UNLESS OTHERWISE SPECIFIED:		NAME	DATE	<b>AndyMark Inc.</b> TITLE: <b>Sonic Shifter          Spacer</b>		
DIMENSIONS ARE IN INCHES		DRAWN	CGTN			4/30/13
TOLERANCES:		CHECKED				
FRACTIONAL ±		ENG APPR.				
ANGULAR: MACH ± BEND ±		MFG APPR.				
TWO PLACE DECIMAL ±0.01		Q.A.				
THREE PLACE DECIMAL ±0.005		COMMENTS:				
INTERPRET GEOMETRIC TOLERANCING PER:				SIZE	DWG. NO.	
MATERIAL				<b>A</b>	<b>am-2508</b>	
FINISH					<b>3</b>	
5052 Aluminum				SCALE: 1:1	WEIGHT:	
Black Wrinkled Powder Coat					SHEET 1 OF 1	
DO NOT SCALE DRAWING

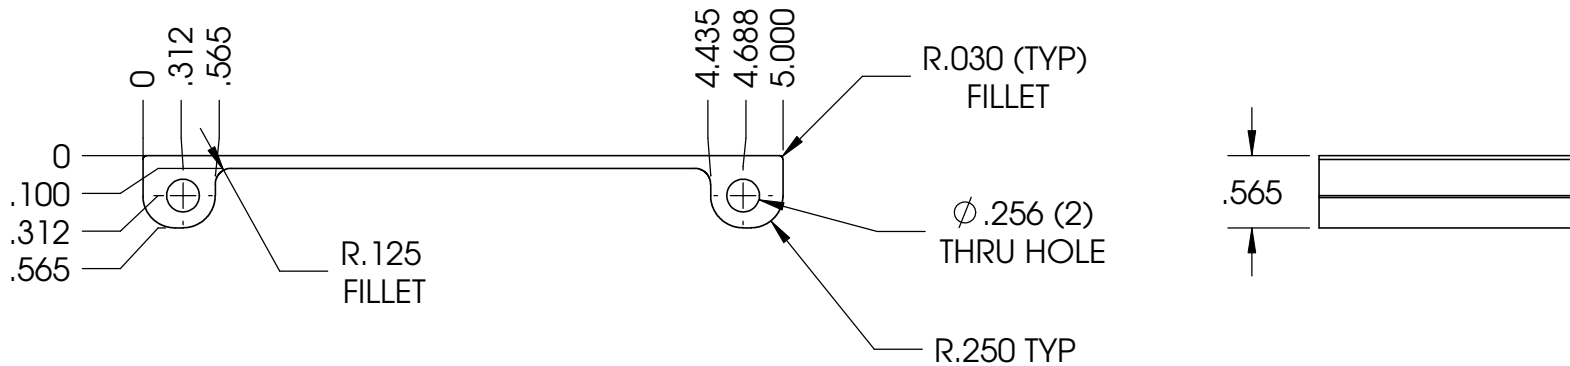
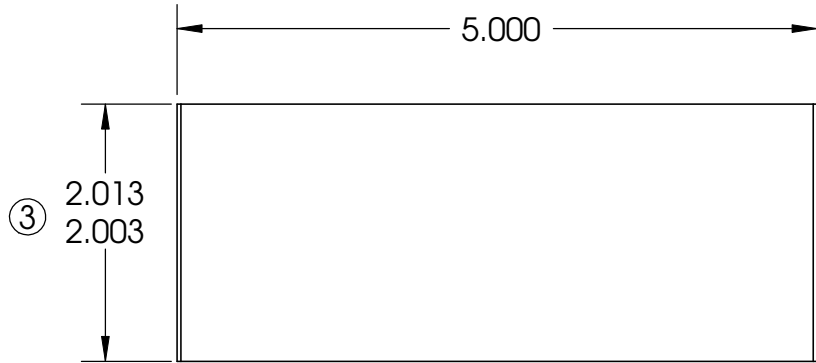
REVISIONS				
ZONE	REV.	DESCRIPTION	DATE	APPROVED
	3	Increased spacer thickness because originally under spec at 1.998"	2/5/2014	BTM
